Engineering Change Notification

This notice is to inform you of a change to the following LCD products:

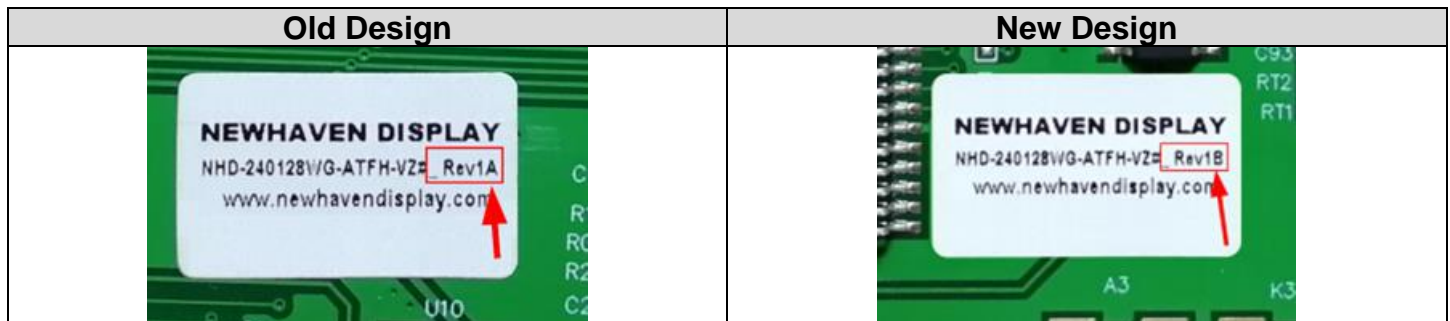
The RA6963-N controller IC used in these displays has been discontinued and replaced by RA6963-N1, which is an alternative version of the same controller.

The new version will be labeled with a different revision control number after the part number. See example below. The same revision control number may not apply for all models.
